RE: Waste Rock Site Culvert, Canyon Fuel Company, LLC, Skyline Mine, C/007/005, Task ID 4978

Attached to this letter is pertinent information addressing modifications to the Skyline Mine M&RP to include the installation of a culvert at the Waste Rock Site. The culvert will carry runoff from the undisturbed ditch, UD-6B, to the adjacent natural drainage. The permit modifications consist of: 1) referencing the addition of the culvert in Section 3.2; 2) updates to Plates 3.2.8-1 and 3.2.8-2 to show the culvert; 3) the addition of Plate 3.2.8-1a detailing the culvert design; 4) updates to the bond calculations in Section 4.3 to accommodate the demolition and disposal of the concrete, culvert, and backfilling; and 5) relevant design information for the culvert.

Title: Waste Rock Site Culvert Task ID #4978

Addition of culvert from undisturbed ditch to existing drainage CLEAN COPIES (2)

Waste Rock Site Culvert and Riprap Design			
HCR 35 BOX380, HELPER, UT, 84528 435-448-2832	DATE: 09/09/15	CK.BY: JArmstrong	REVISION:
DWG. NO.: 3.2.8-1a	SCALE: NST	DR.BY: BBAILEY	0
CAD FILE: P:\PERMITS\SKY\WORKING\2015_WRS_culvert\3.2.8-1a			09/09/15

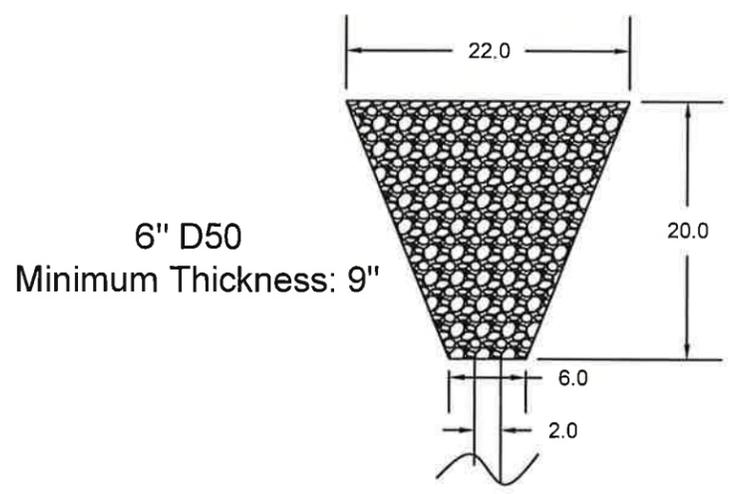
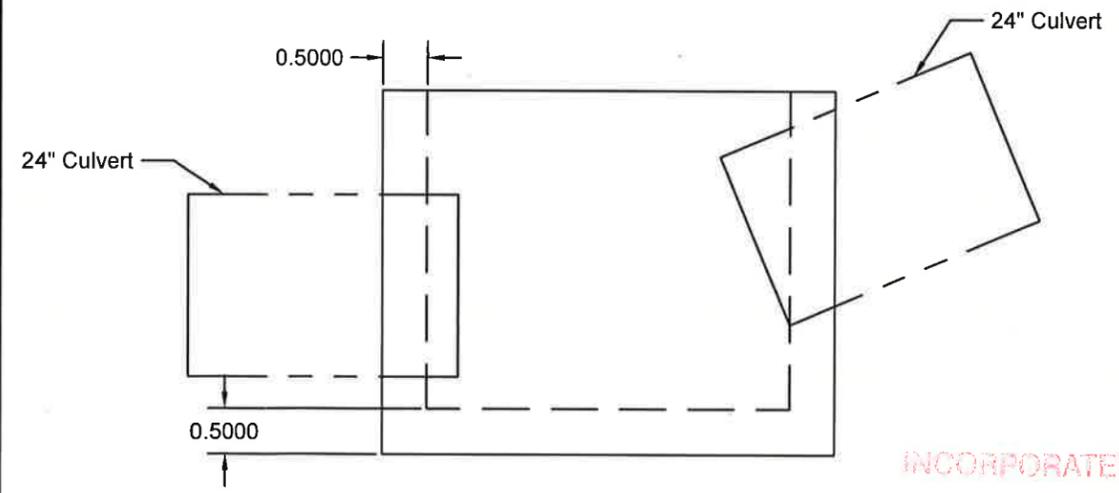
Outlet Riprap Design

Concrete Sediment Box

SCALE: 1" = 150'
DATE: 5/02/07
CK. BY: C WINTERS
DWG. NO.: 3.2.8-1
DR. BY: B REES

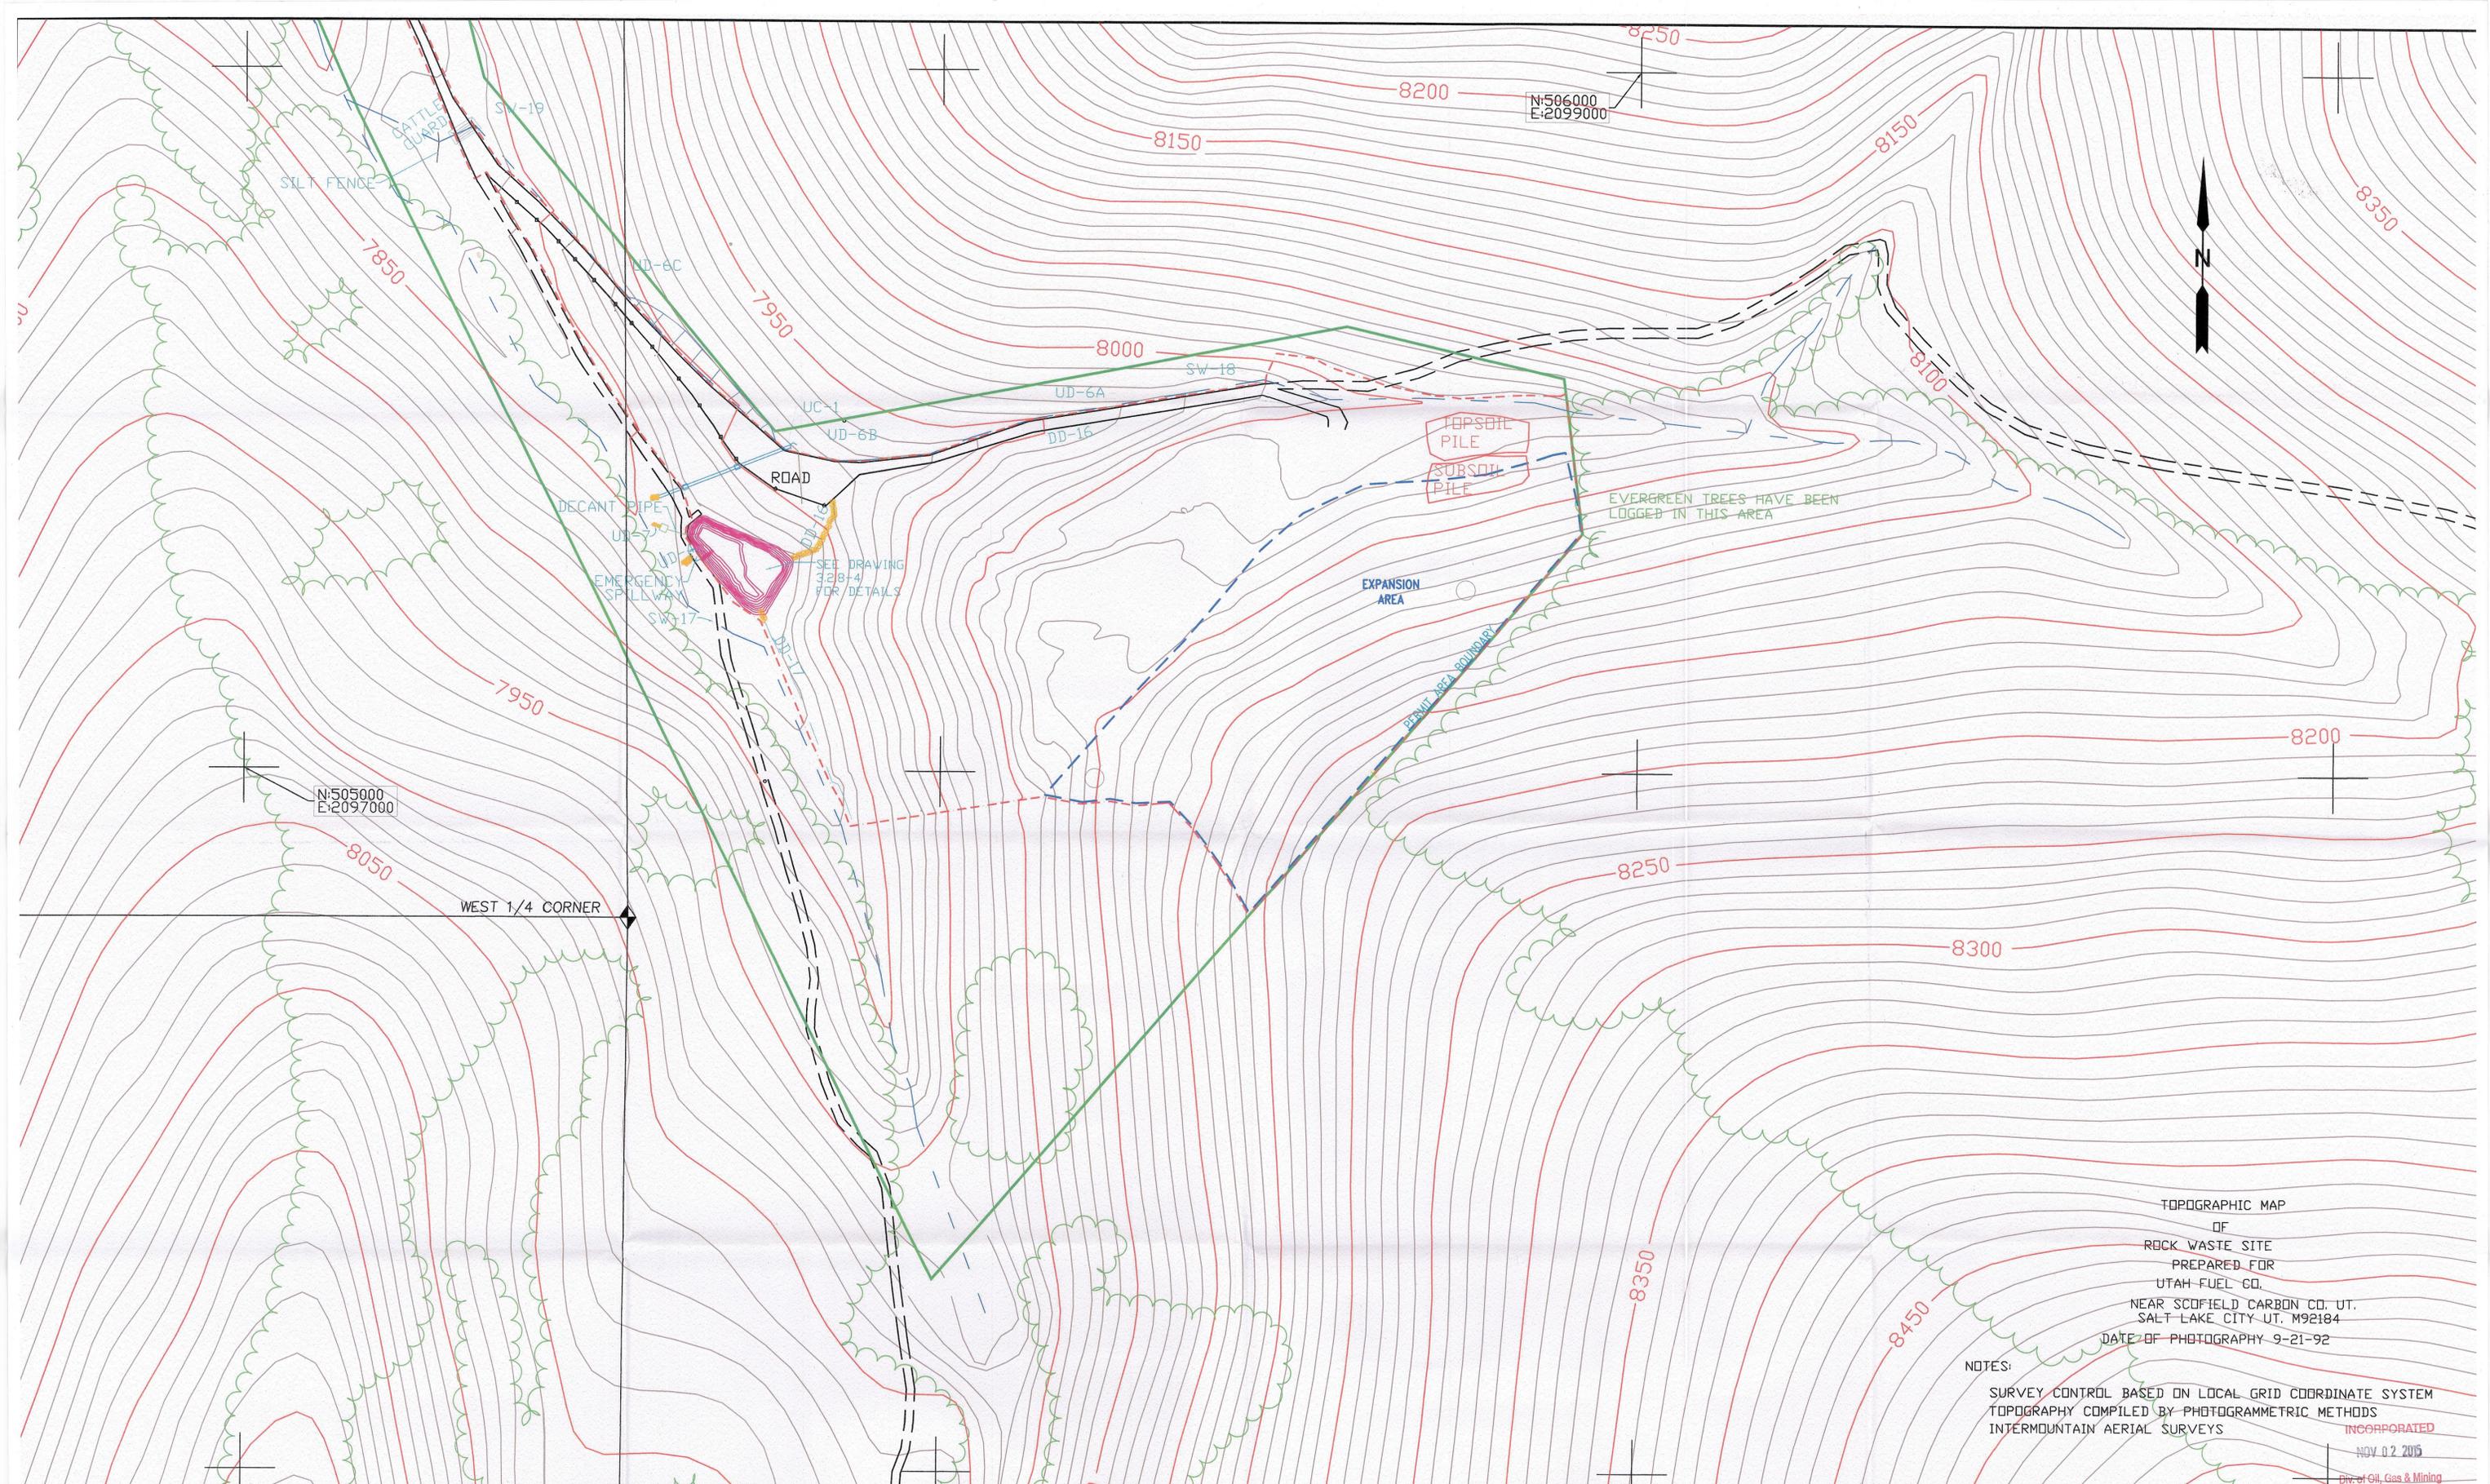
DATE	No.	REVISIONS	APP.	CHK.	DR.
7-89	1	ADD AREA 24-A			
9-20-89	2	DITCH NUMBER'S CHANGED			
9-29-89	3	NOTE ADDED			
7-1-92	4	REVISED FOR PIT EXPANSION			
5-19-94	5	ADD AREA 24-A			
5-02-07	6	ADDED EXPANDED PERMIT AND DISTURBED AREA, AS-BUILT SEDIMENT POND, AND UNIMPROVED ROAD			
5-15-14	7	ADDED Topsoil/Subsoil Piles, Removed "Access Road" from title block			
9-9-15	8	ADDED UC-1, ADDED EXPANSION AREA FROM PLATE 3.2.8-2
